**TWIN CITY WATER AND SEWER DISTRICT EAST 1ST ST., UHRICHSVILLE, OHIO
TUSCARAWAS COUNTY, OHIO
PROPOSED
WATER MAIN AND PAVEMENT RESURFACING**

ADDENDUM # 1

**JANUARY 20, 2021
Thrasher Project #101-010-10014**

TWIN CITY WATER AND SEWER DISTRICT
 EAST 1st. STREET, UHRICHVILLE, OHIO
 WATER MAIN AND PAVEMENT RESURFACING
 TUSCARAWAS COUNTY, OHIO
 SANITARY SEWER PROFILES

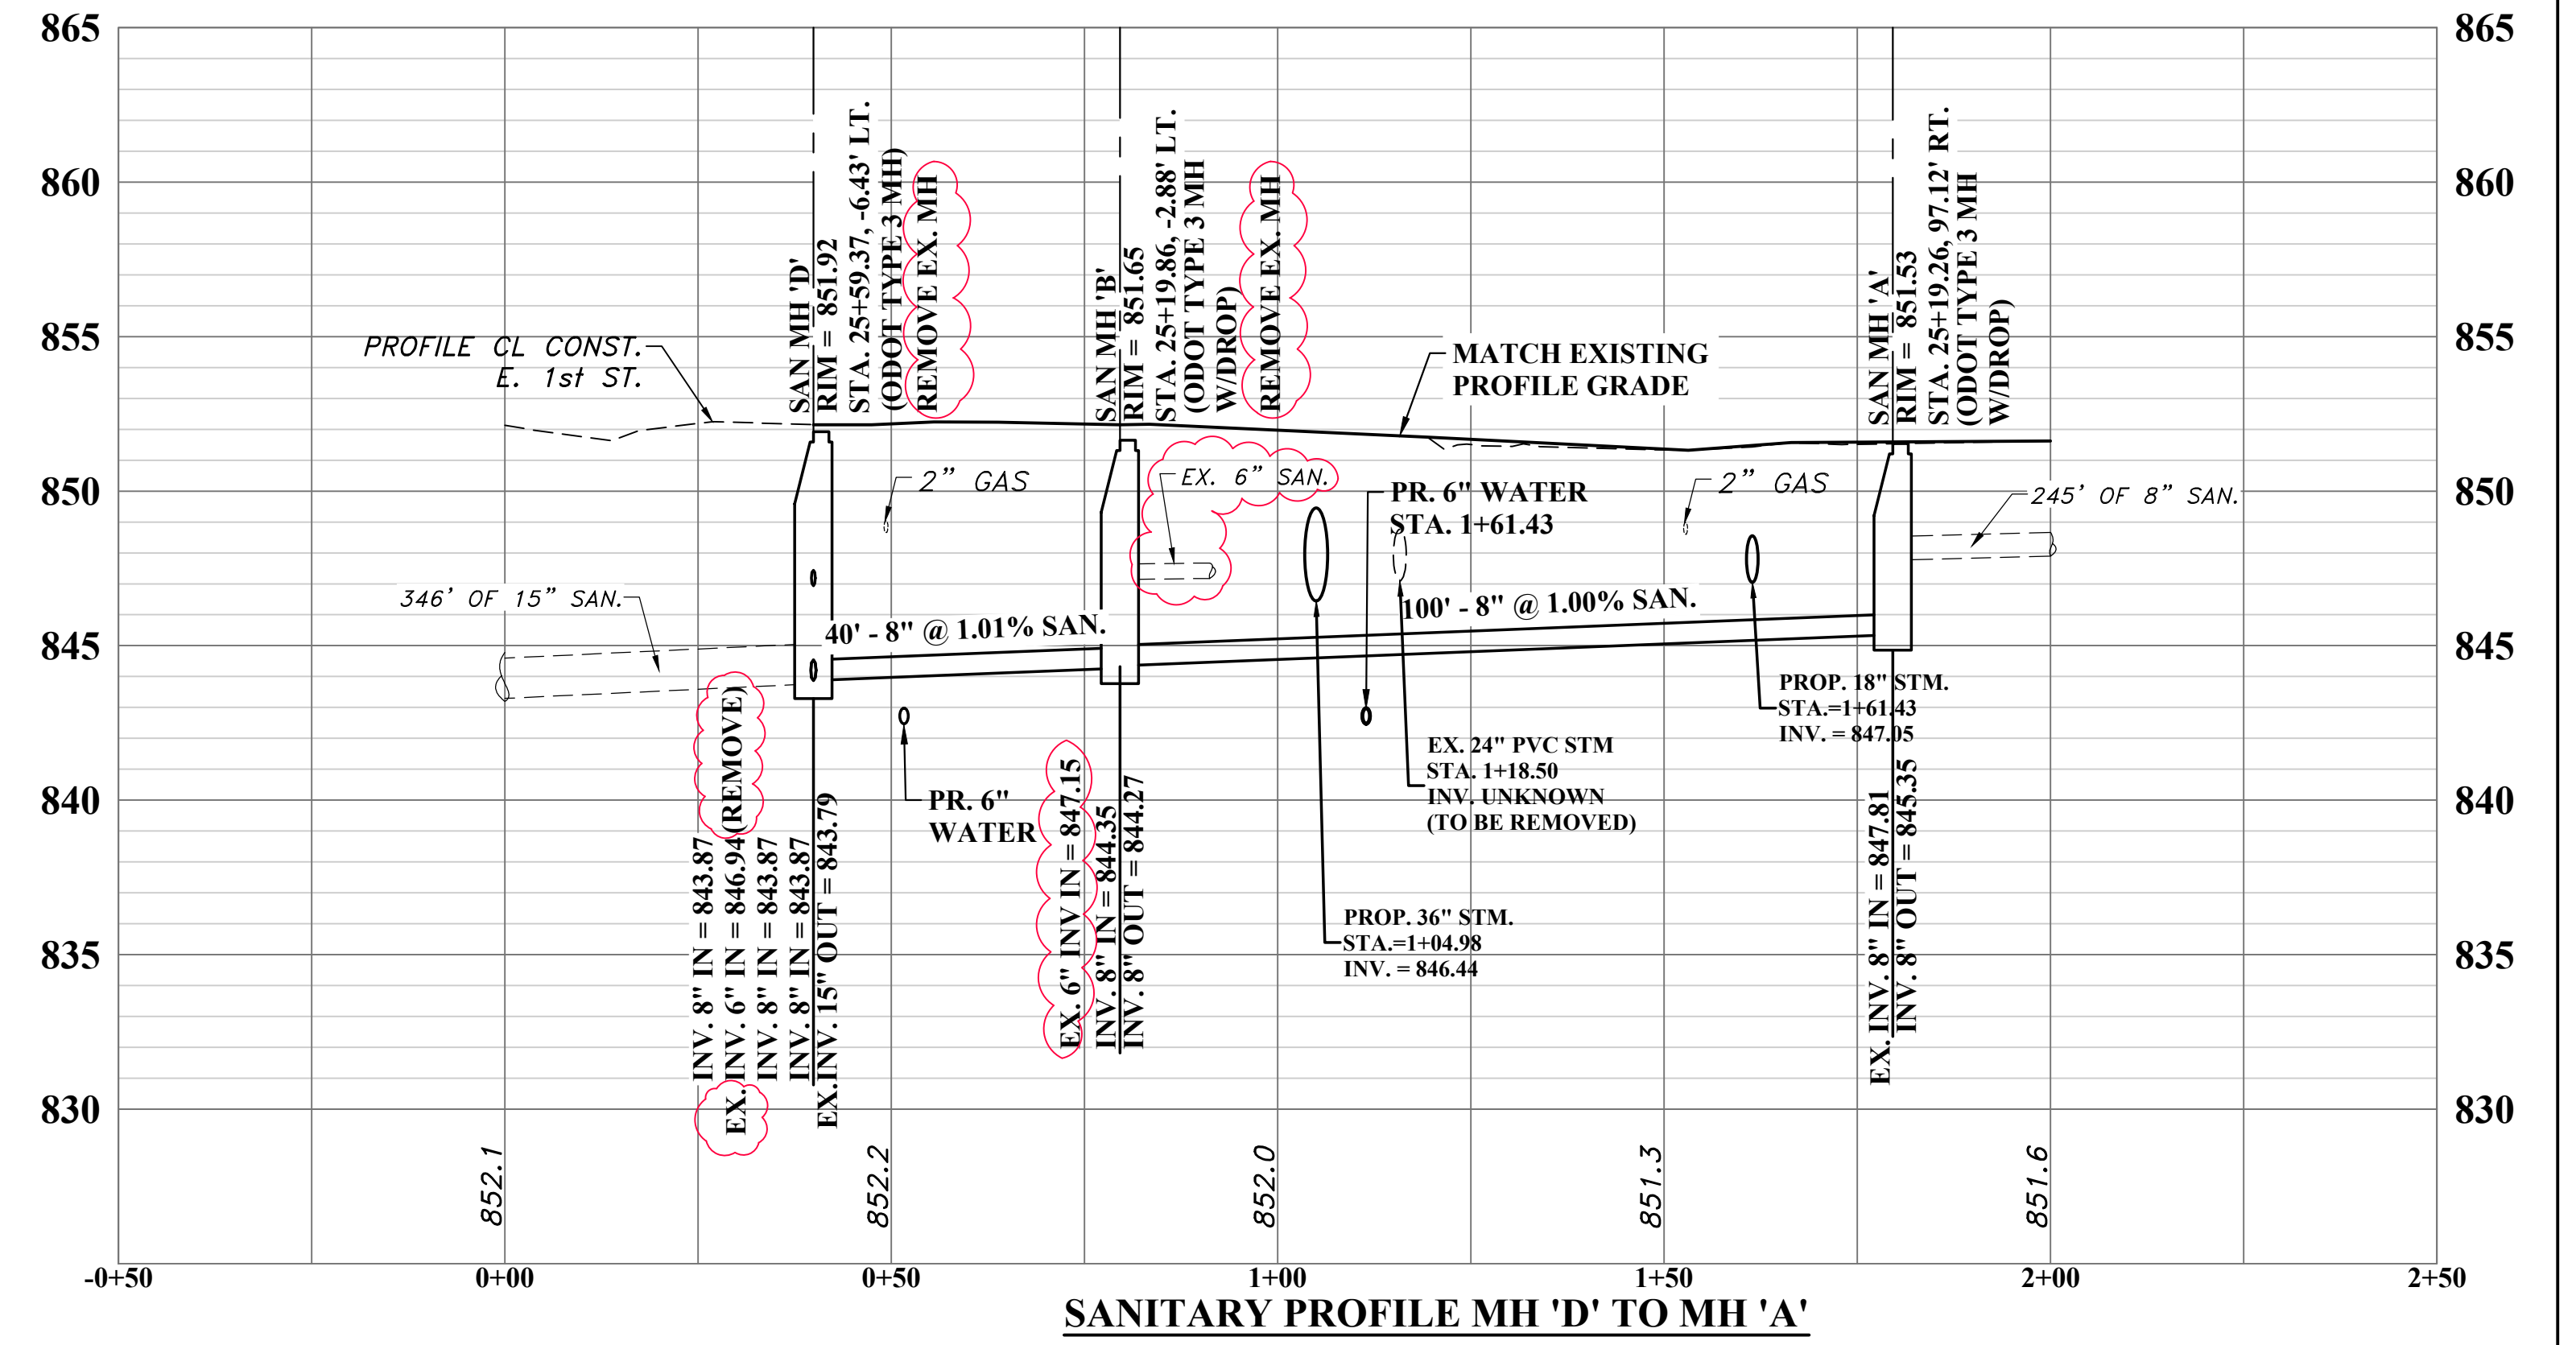
- Changed 8” PVC SDR-35 from 550 LF to 238 LF
7. Plan Sheet 15: Storm Sewer Profiles
 - Added storm sewer text
 8. Plan Sheet 16: Sanitary Sewer Profiles
 - Removed the text “Remove and Replace” from sanitary manholes A,B,C and E
 - Revised existing sanitary text
 9. Plan Sheet 19: Standard Details
 - Changed waterline trench detail with crushed stone cover to sand
 10. Plan Sheet 20: Standard Details
 - Changed Utility Trench Detail label to read Storm/Sanitary Utility Detail
 11. Plan Sheet 22: Standard Details
 - Added Sanitary Manhole Drop Structure detail
 12. Plan Sheet 24: Standard Details
 - Added Catch Basin/Manhole #4 Detail
 - Changed the max outlet diameter for MH#4 Detail from 24” to 30”

ADDENDUM#1 NOTE: REMOVED THE TEXT "REMOVE AND REPLACE" FROM SANITARY MANHOLES A AND C.

NO.	BY	DATE	DESCRIPTION
1	JAB	1/19/21	ADDENDUM#1 - EX. SANITARY LINE/STRUCTURE TEXT CLARIFICATION

WATERLINE TRENCH DETAIL

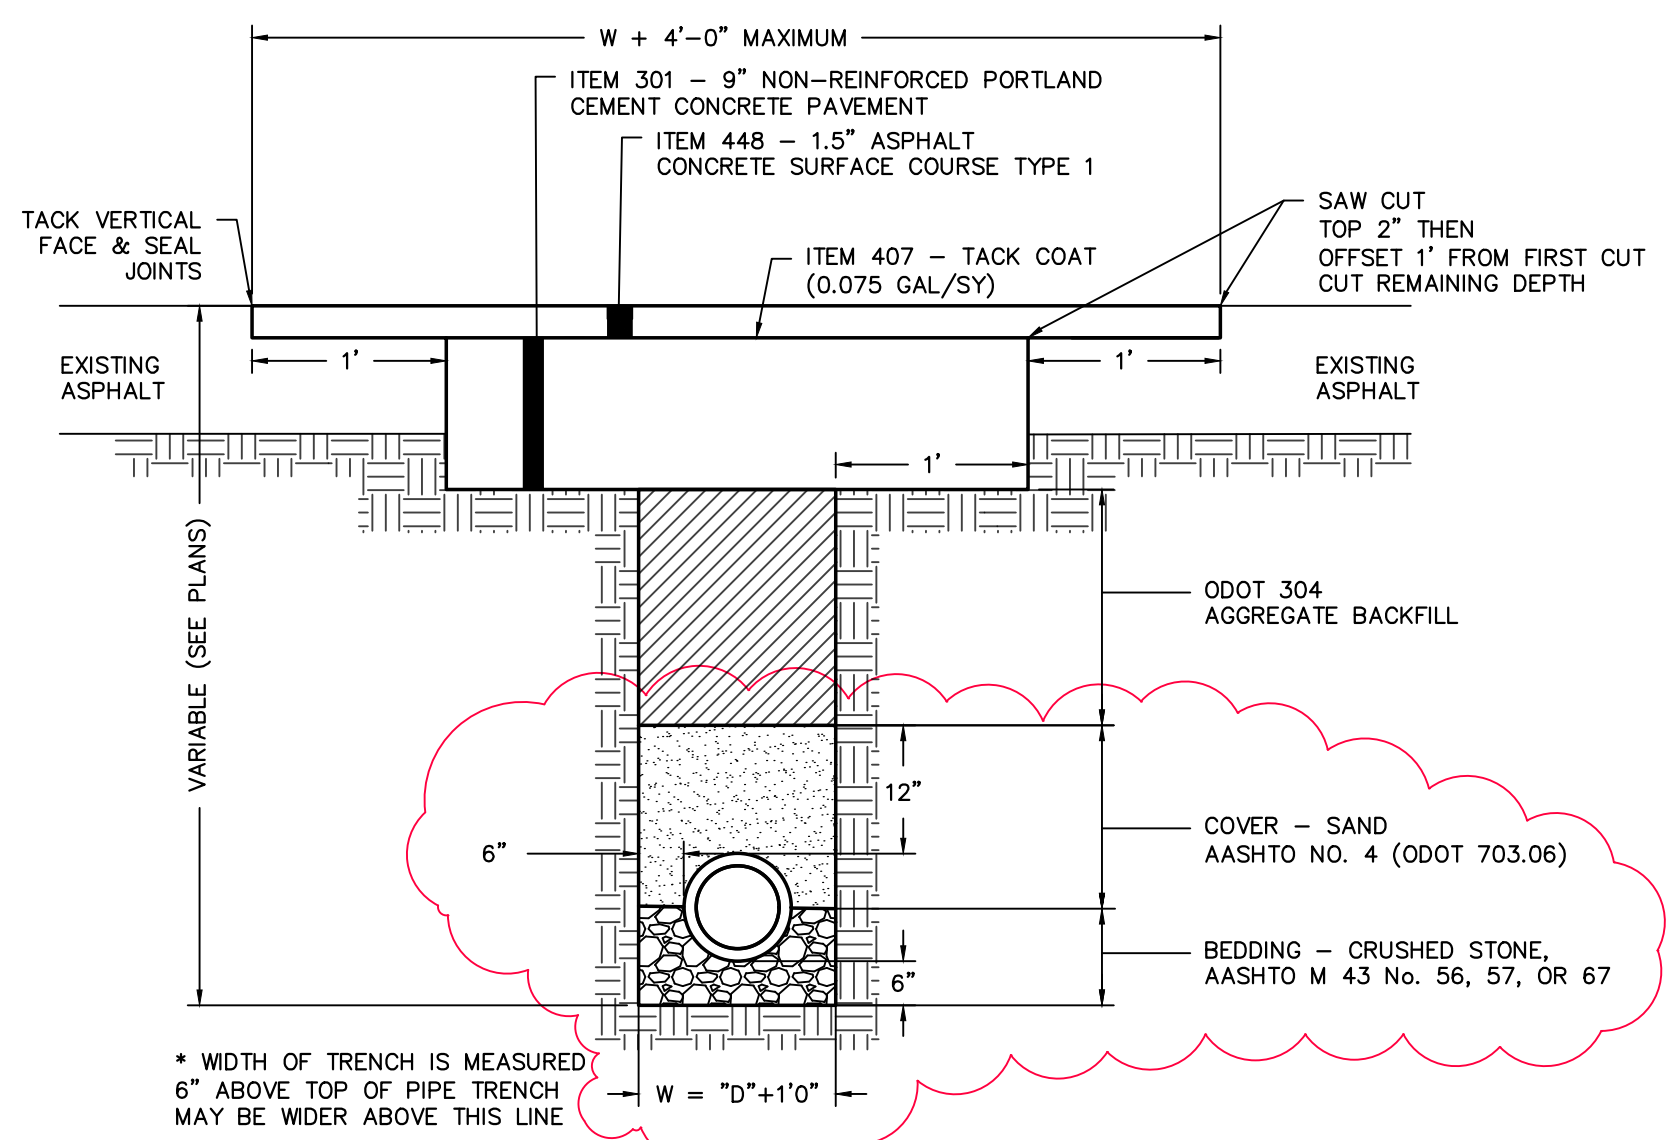
9. Can sand be used in place of gravel for bedding material for waterline, sanitary and storm water piping? Per drawing waterline trench detail on page 19 and utility trench detail page 20.

See revised sheet 19.

NO.	BY	DATE	DESCRIPTION
1	JAB	1/19/21	WATERLINE TRENCH COVER CHANGED FROM GRAVEL TO SAND

SANITARY MANHOLE DROP STRUCTURE DETAIL (REFERENCE-STARK COUNTY DETAIL DWG. NO. 15)

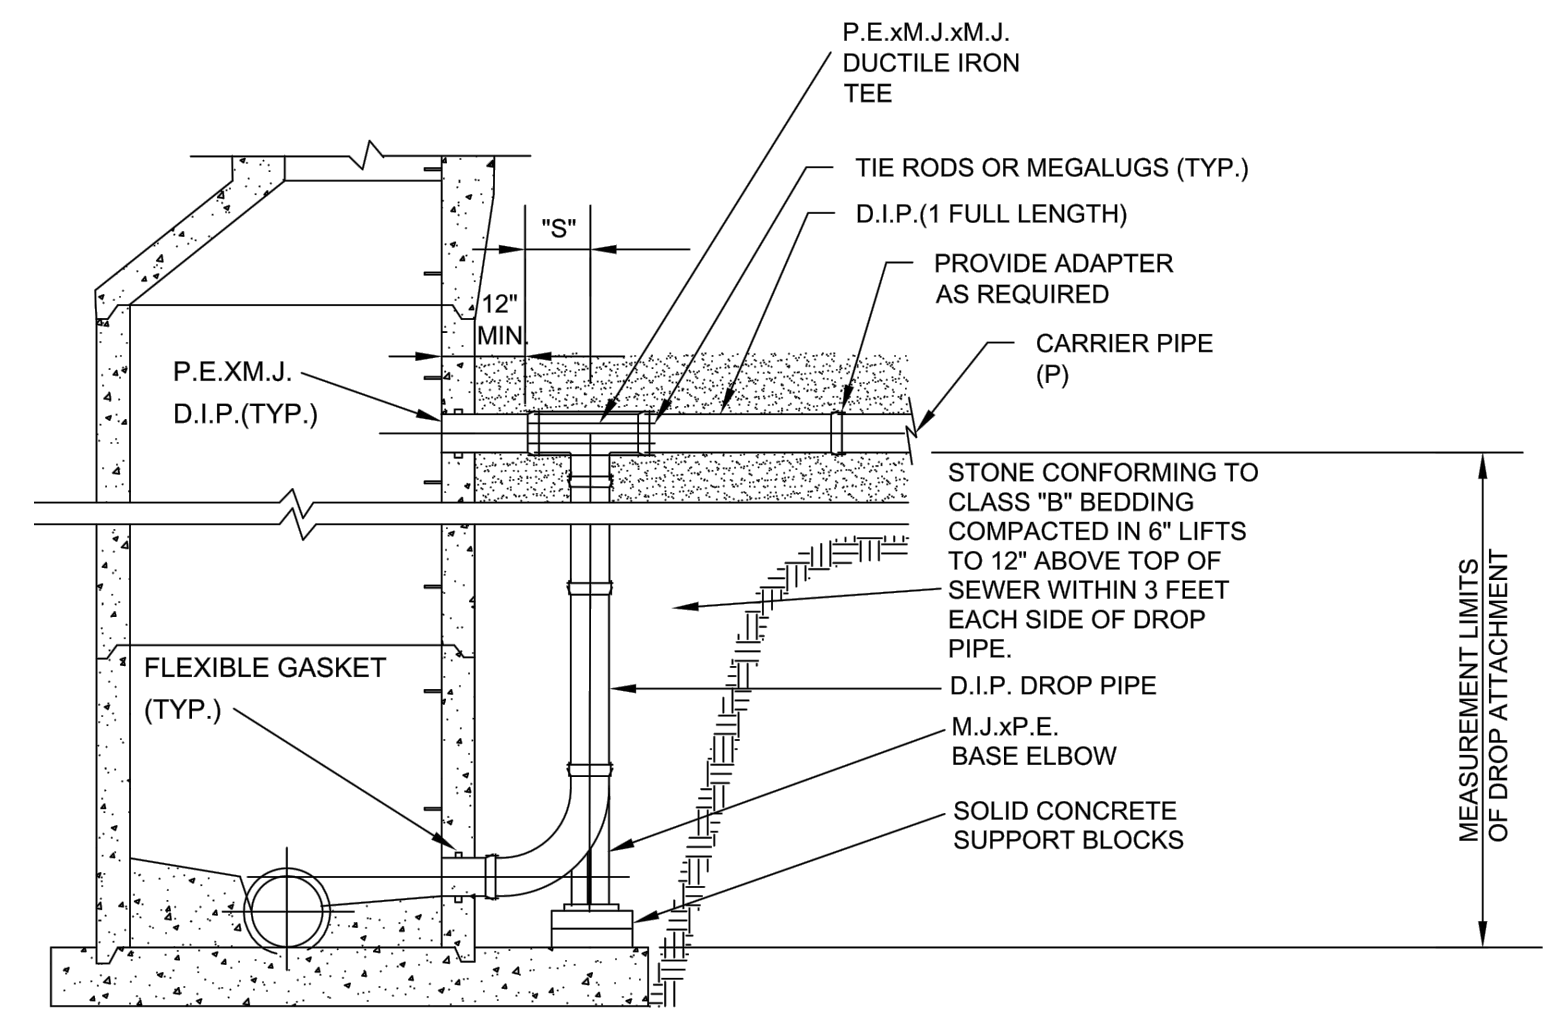
4. What is detail of the drop manholes, will they be interior or exterior style drops?

See revised sheet 22.

ADDENDUM#1 NOTE: ADDED SANITARY MANHOLE DROP STRUCTURE DETAIL

**CATCH BASIN/MANHOLE #4 DETAIL
 (REFERENCE CITY OF COLUMBUS AA-S21 AND AA-S142)**

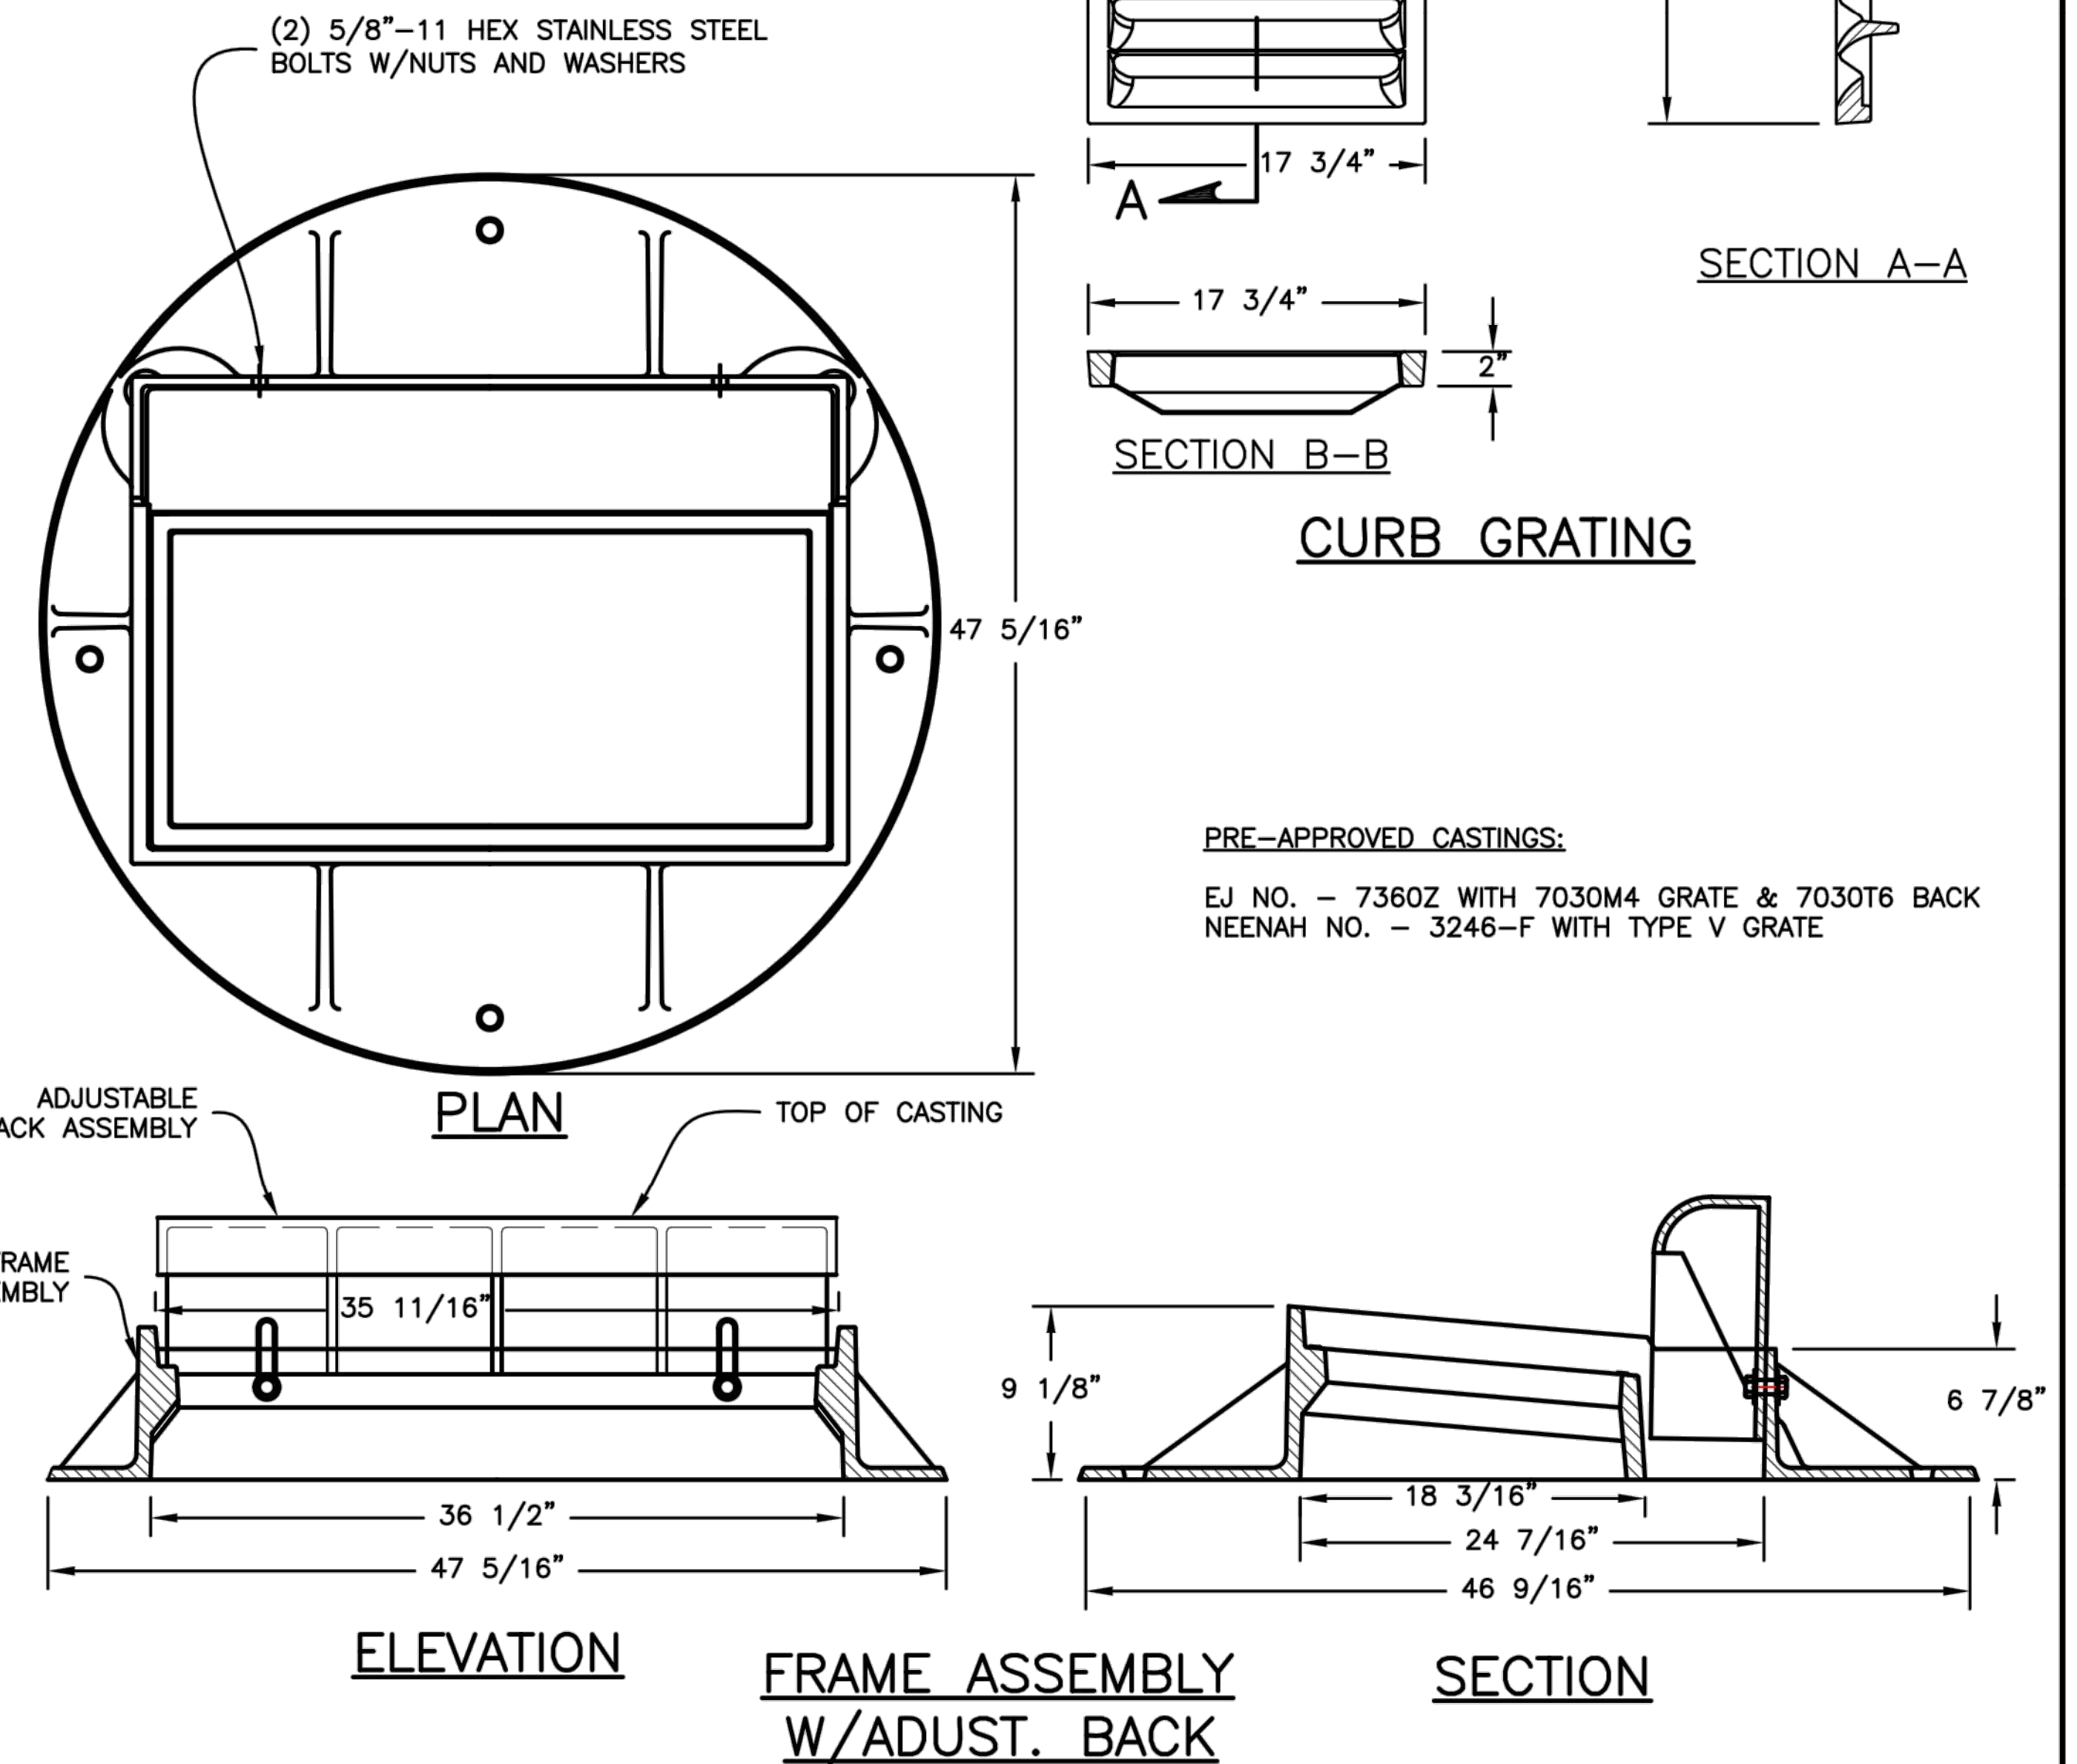
7. Catch #4, can this be modified to be a 48" dia with a 30" pipe leaving the structure at an angle?

See Revised Sheet 24. A 48" I.D. (60" O.D.) manhole shall be used according to City of Columbus Standard Drawing AA-S121 Curb Inlet Manhole. The detail has been modified for this project to allow a 30" pipe outlet.

ADDENDUM#1 NOTE: RCP 30" OUTLET PIPE IS ACCEPTABLE FOR THE MANHOLE #4 STRUCTURE

NO.	BY	DATE	DESCRIPTION
1	JAB	1/19/01	ADDENDUM#1 - ADDED MH#4-AMENDED COLUMBUS DETAIL
